DEVIATION REQUEST AND DECISION FORM

PROJECT INFORMATION – NEW LOG ROAD DEVIATION REQUEST

Project Name : Ellicott Town Center Filing No. 1

TYPICAL ROAD SECTIONS

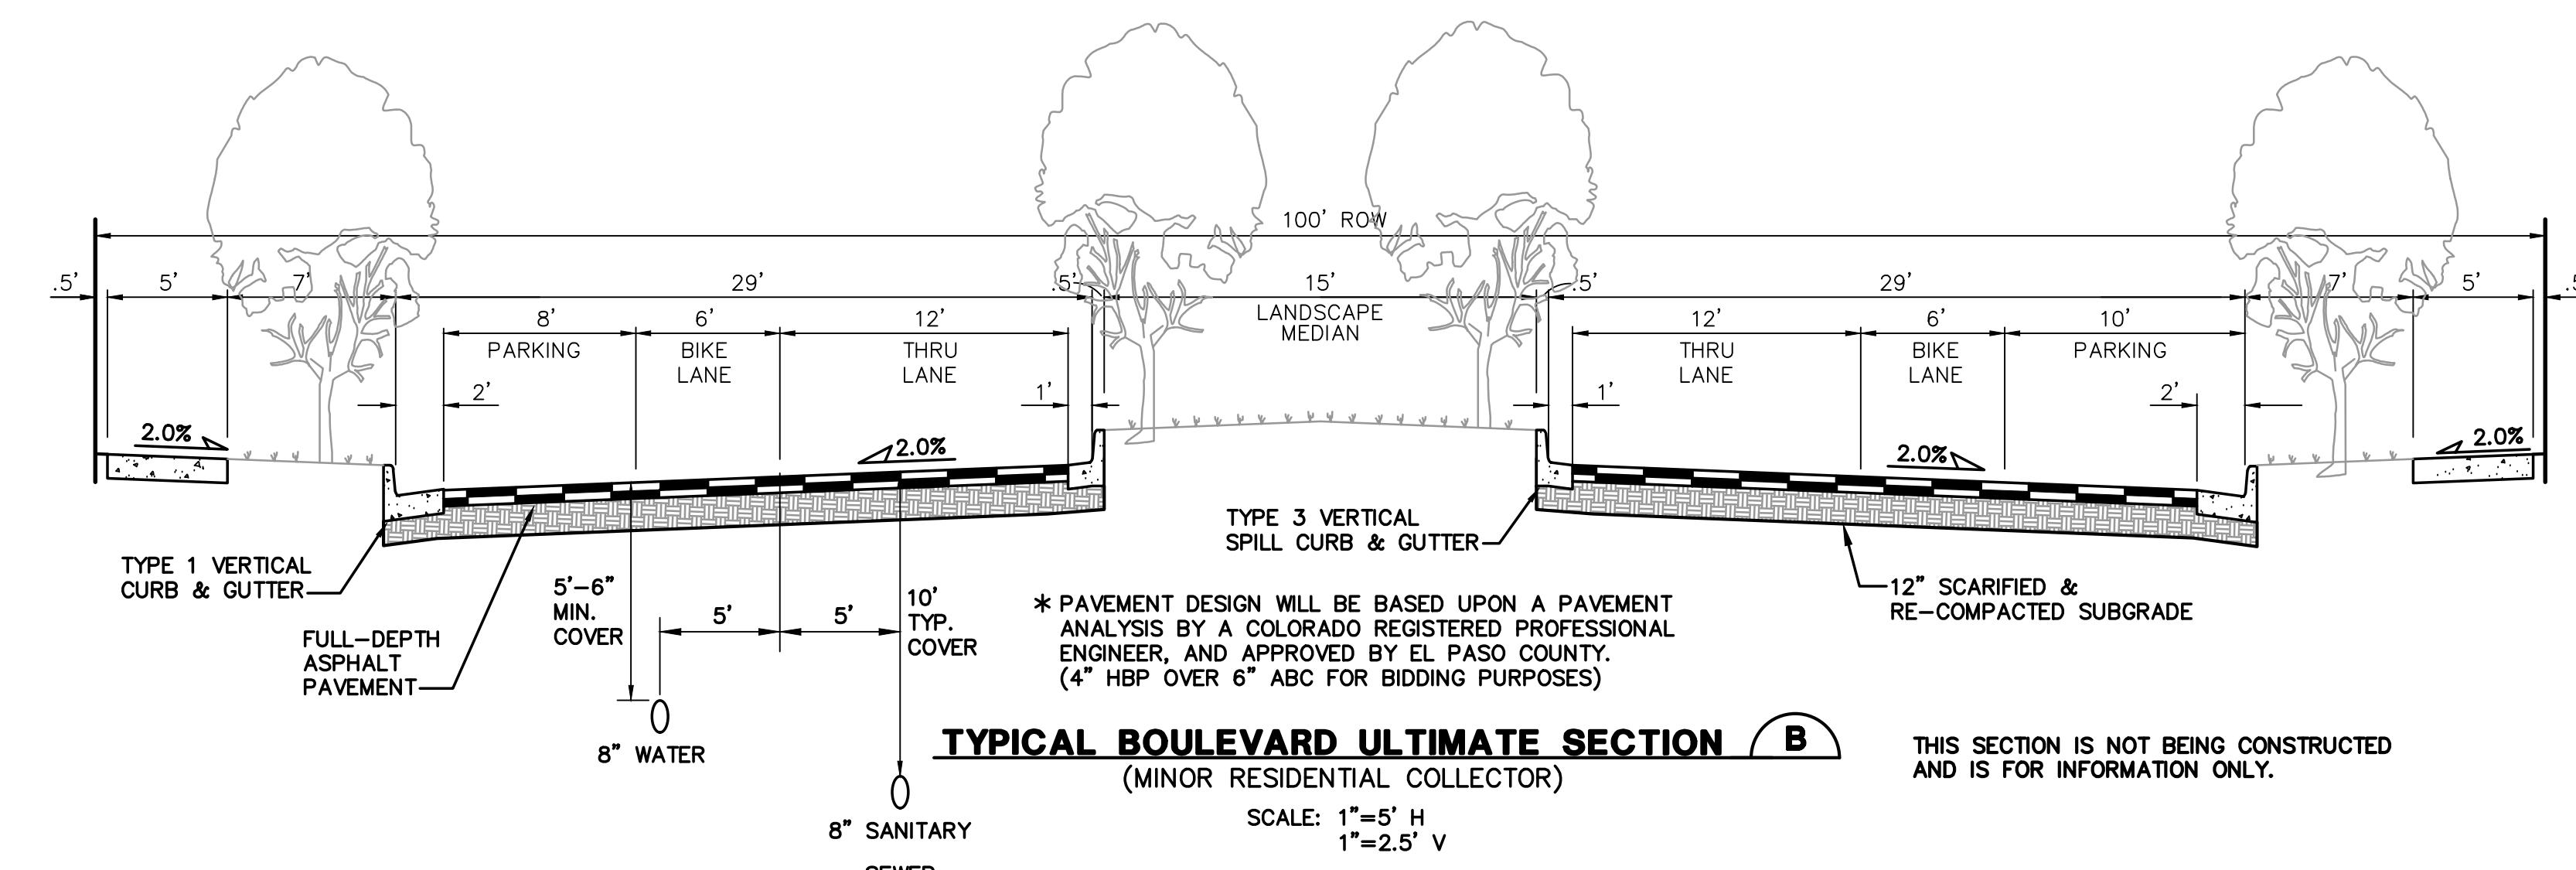
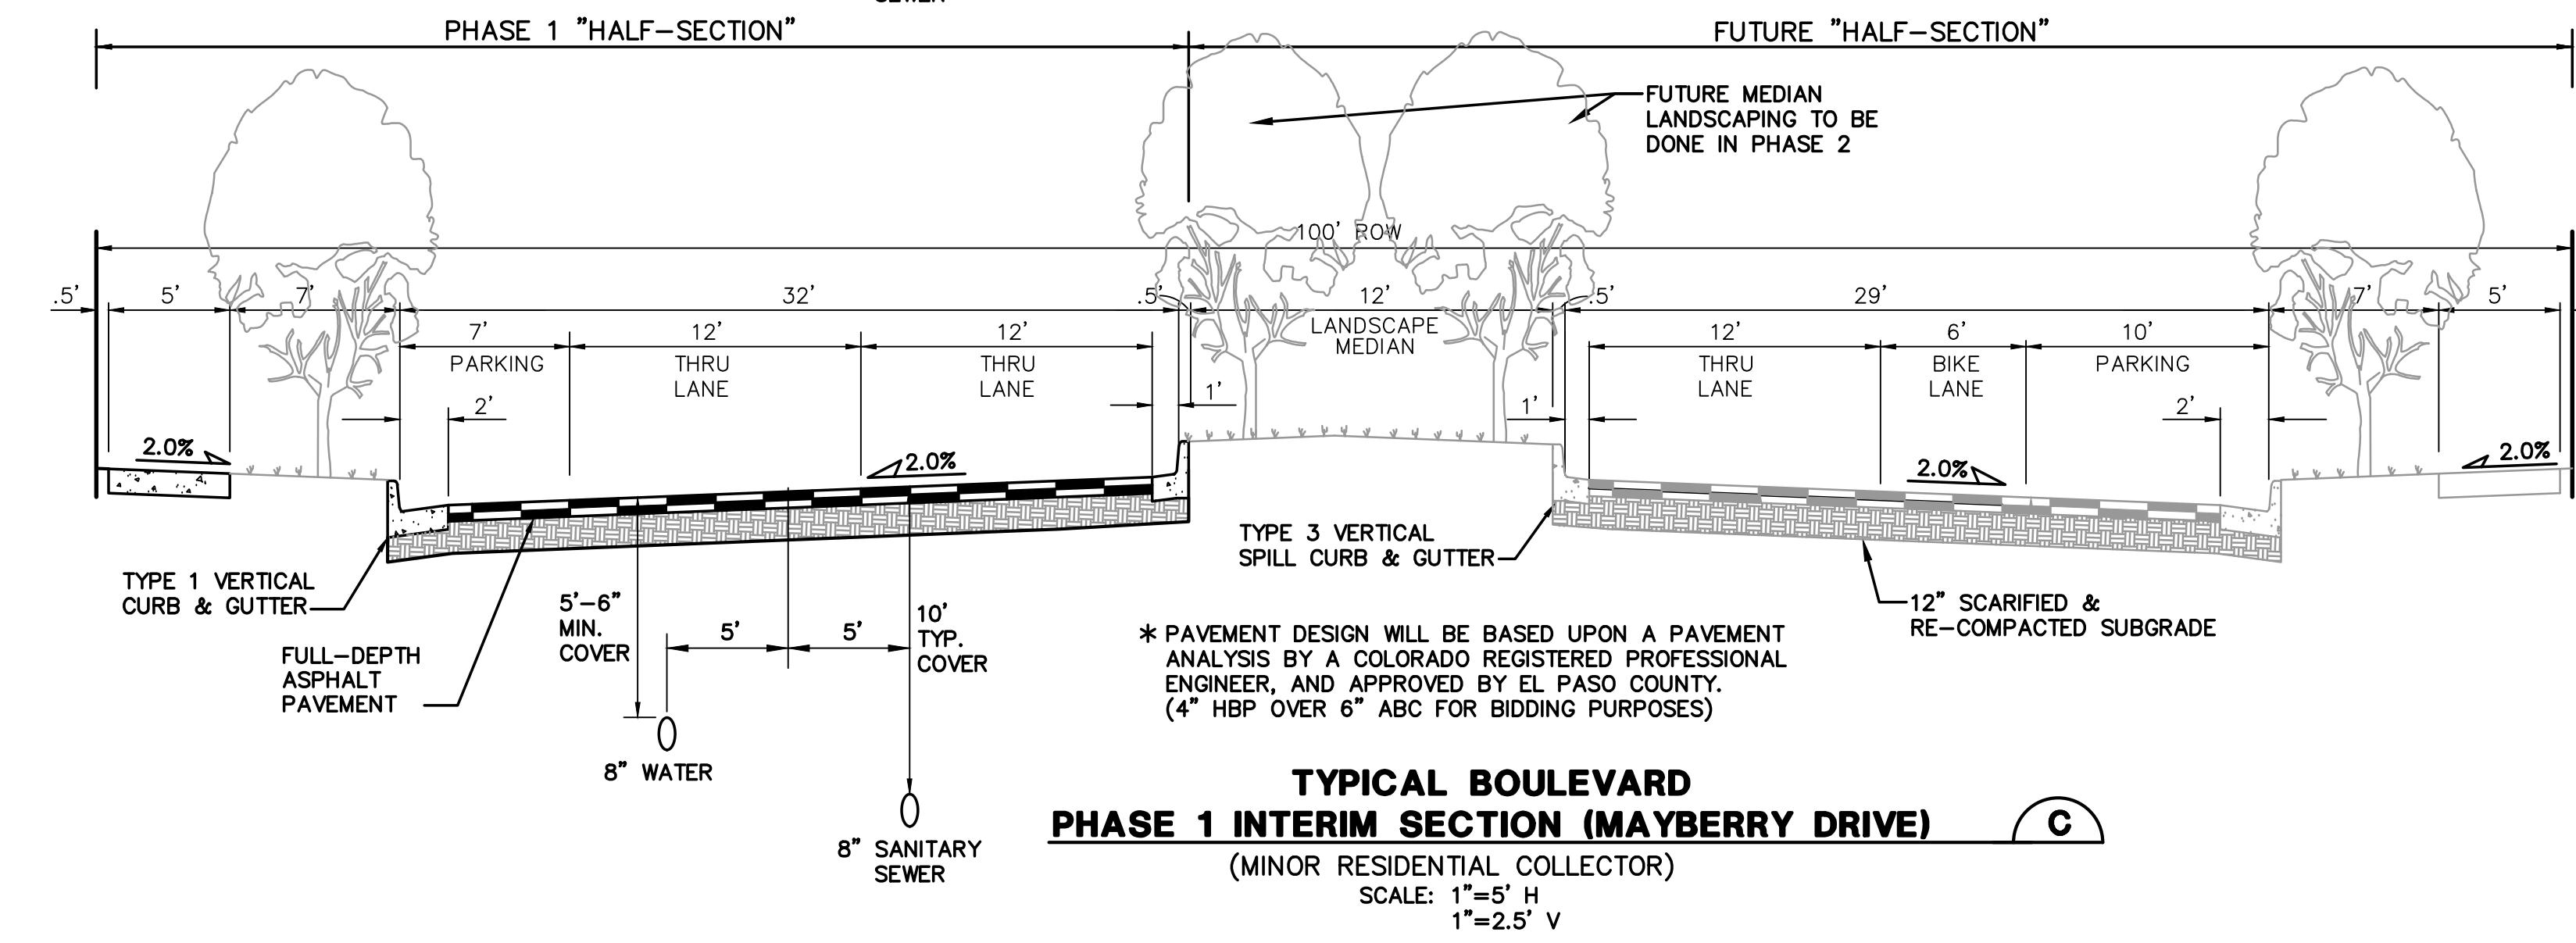
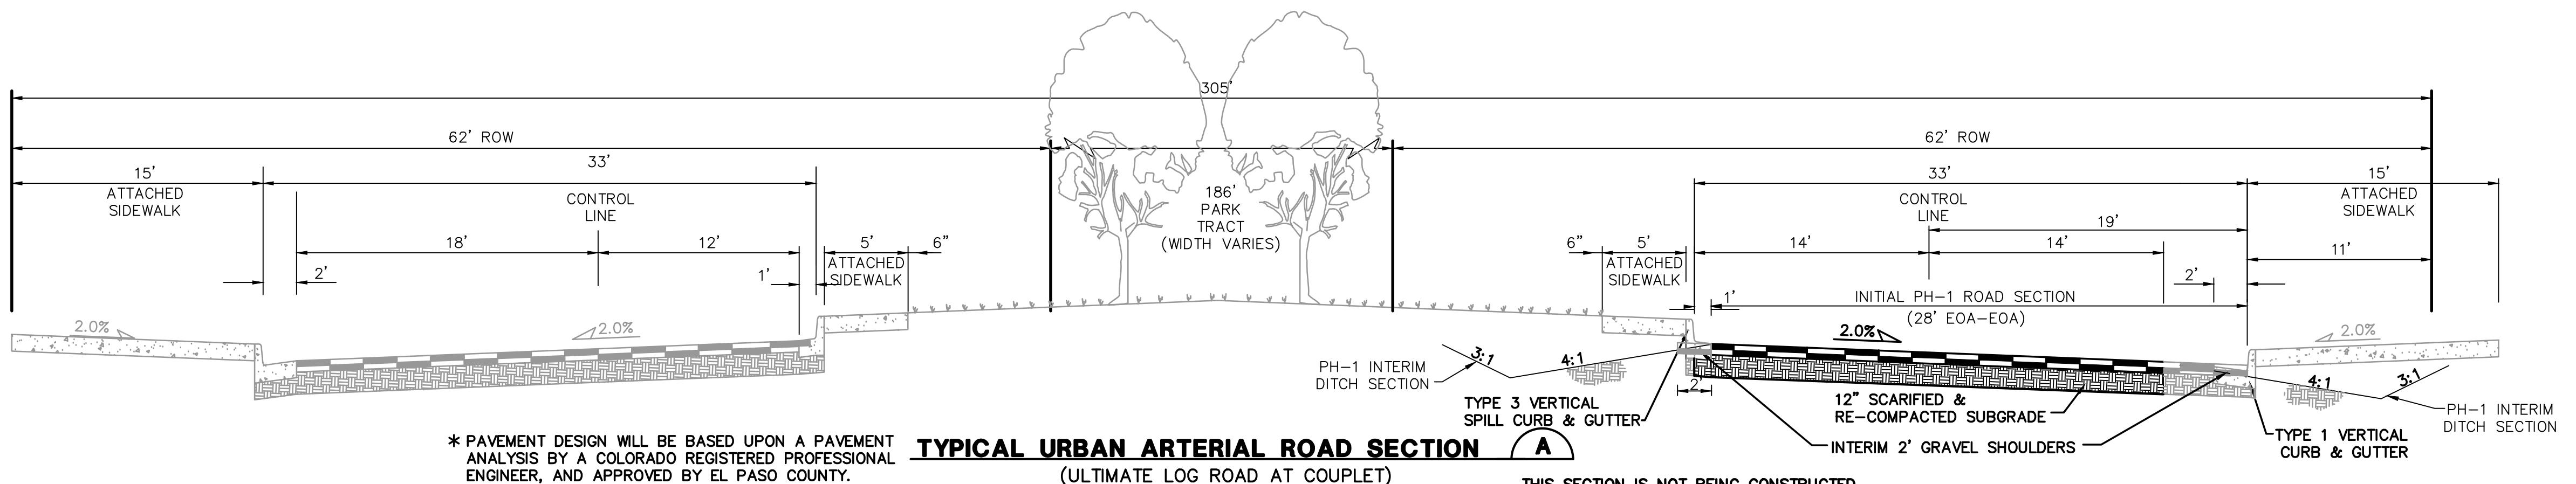
Mayberry Boulevard is classified as an Urban Residential Collector. The proposed deviations consist of modified cross-section elements including an ultimate divided section with landscaped median, and a Phase 1 half-section with a 29-foot asphalt width. The proposed deviations are depicted on the Typical Road Section Drawings (Sections B-C, Sh. TY2).

The current ECM standard is a 36-foot asphalt width for an Urban Residential Collector. The narrower road widths are consistent with new urbanist land planning as approved in the Ellicott Town Center PUD. Minimum travel lane widths of 12 feet are provided in accordance with current ECM standards.

SIGNING & STRIPPING PLAN

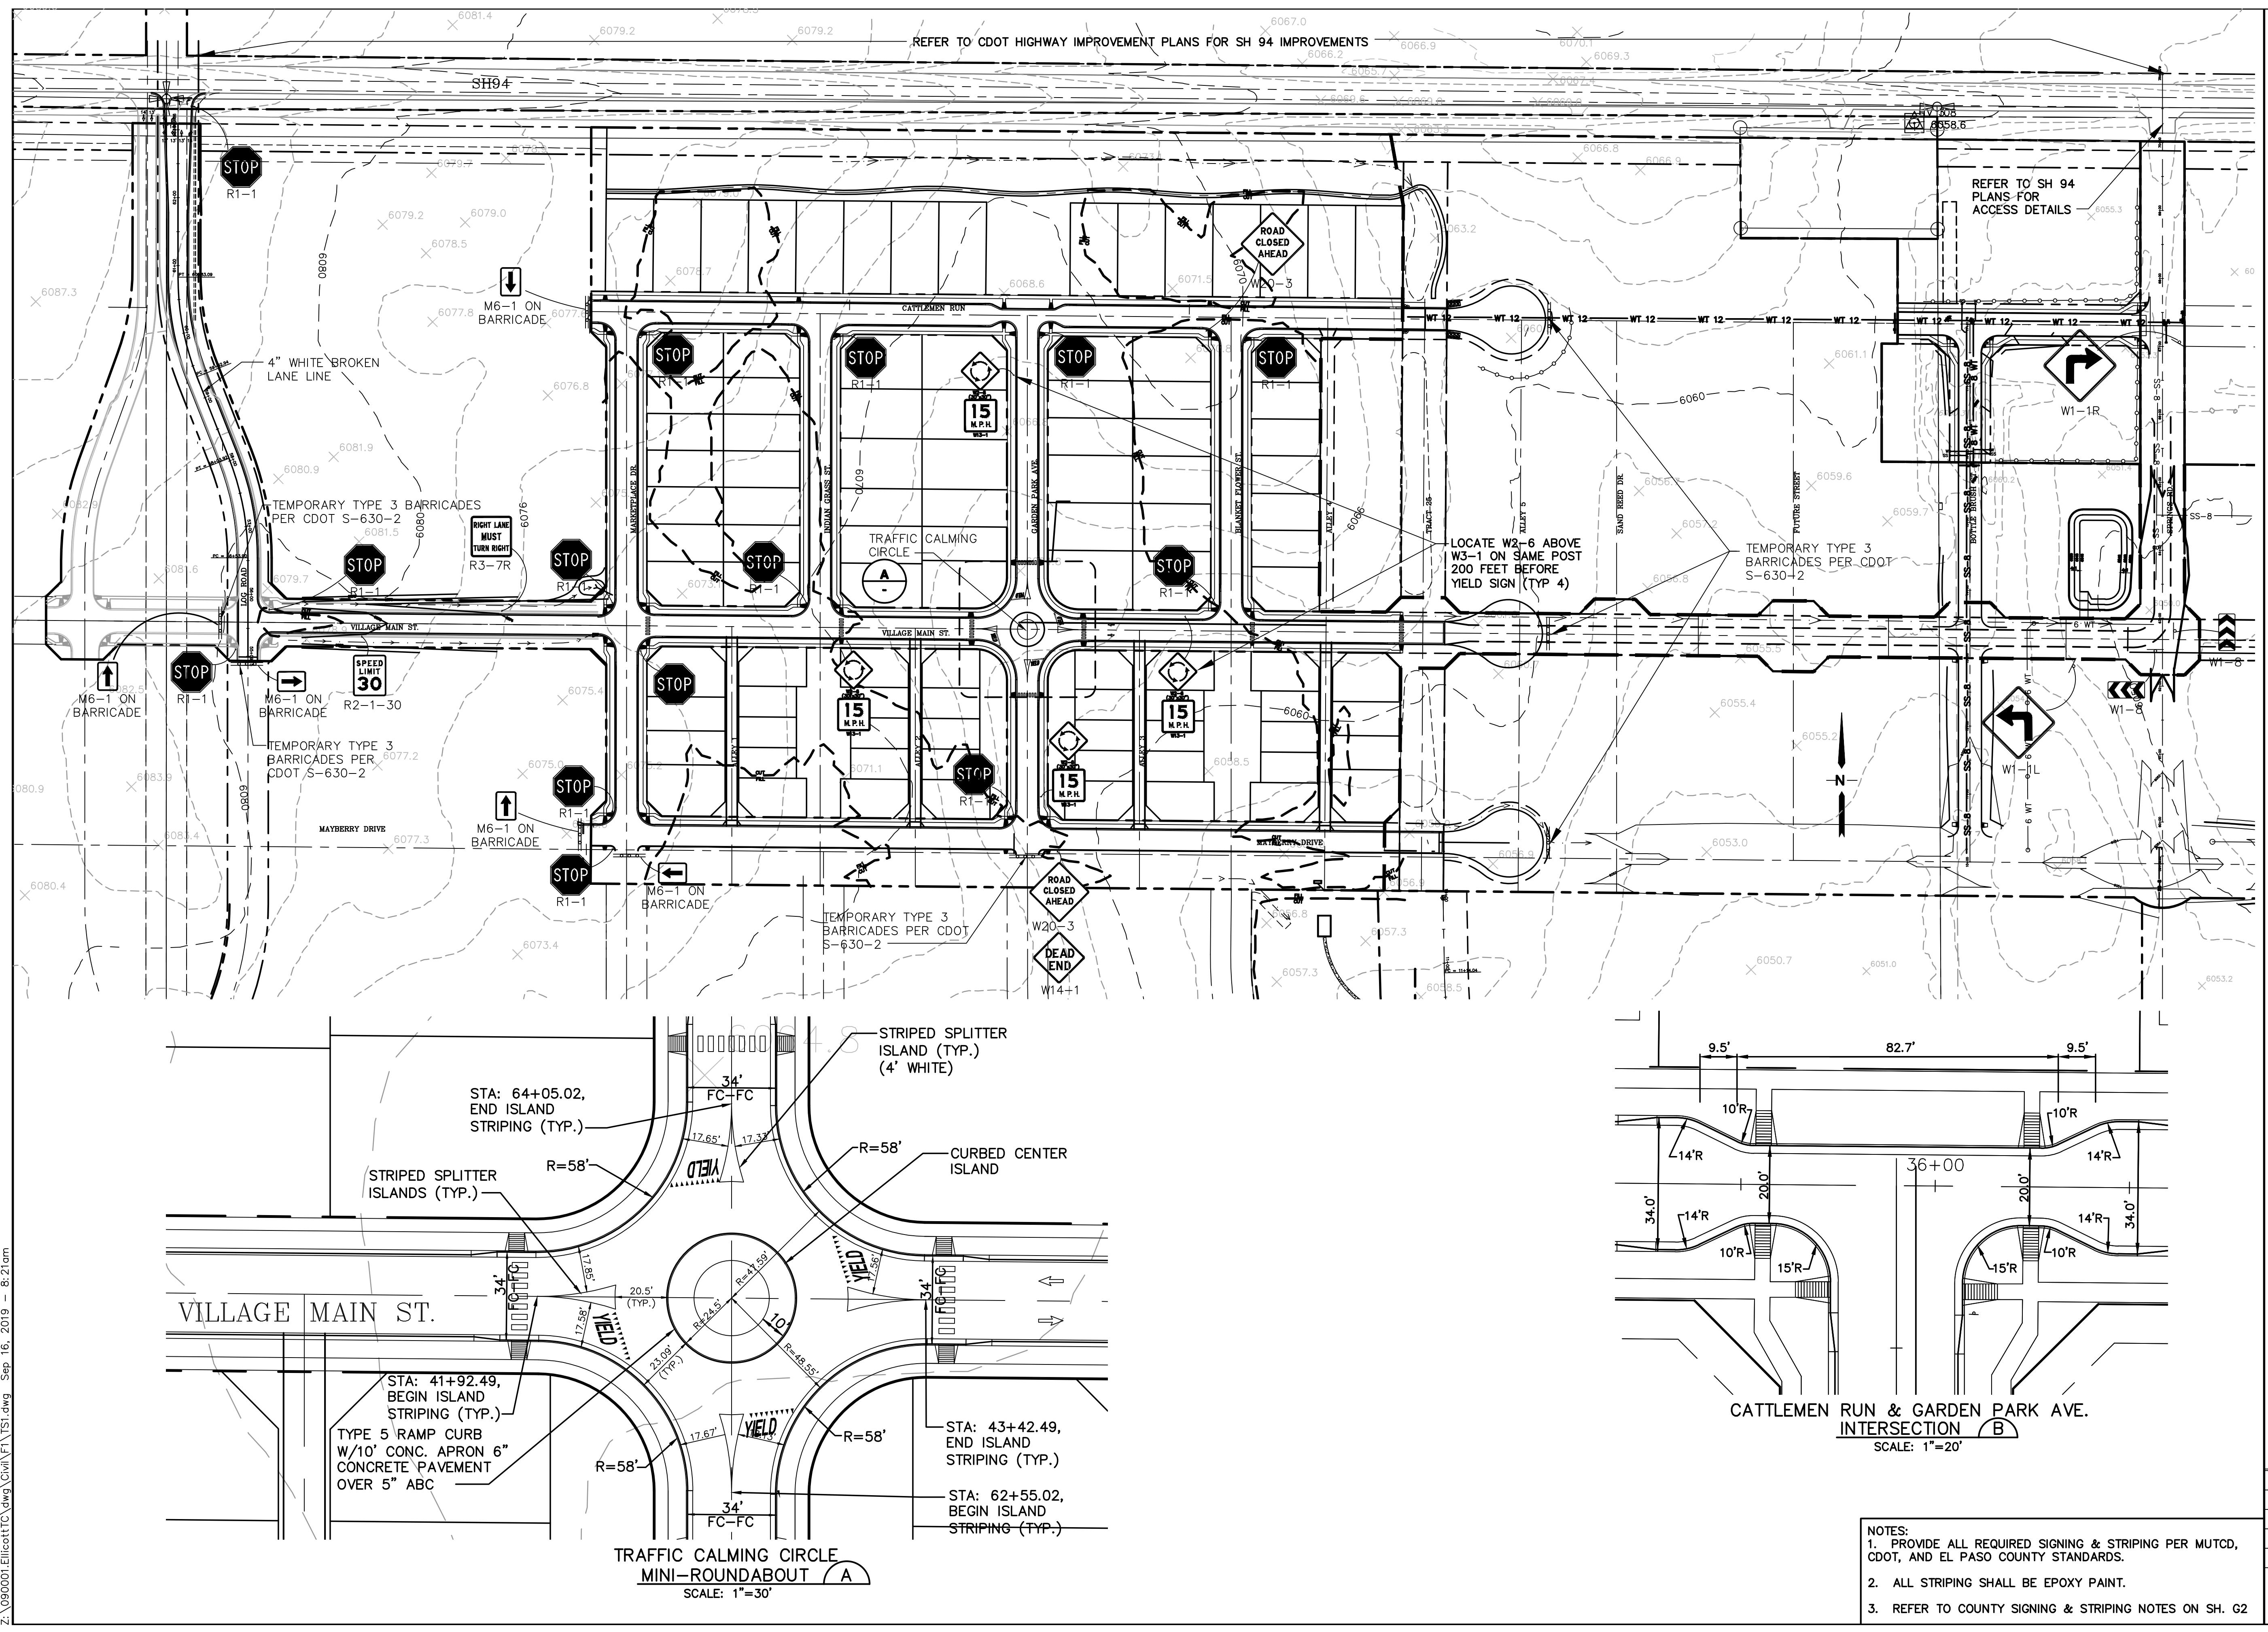
Cattlemen Run is classified as an Urban Local Road. The proposed deviations consist of modified cross-section elements including a “choker” at the intersection of Cattlemen Run and Garden Park Avenue to reduce vehicle speeds. The proposed deviations are depicted on “Intersection Detail B” on the attached Sheet TS1.

Cattlemen Run is classified as an Urban Local Road. The proposed deviations consist of modified cross-section elements including a “choker” at the intersection of Cattlemen Run and Garden Park Avenue to reduce vehicle speeds. The proposed deviations are depicted on “Intersection Detail B” on the attached Sheet TS1. The choker consists of a narrow segment of roadway at the intersection, with the width reduced to a minimum of 20-feet face-of-curb to face-of-curb.

The current ECM standard is a 30-foot asphalt width for an Urban Local Road. The narrower road width is consistent with new urbanist land planning as approved in the Ellicott Town Center PUD. The proposed “choker” is designed to discourage high speeds through this residential block.
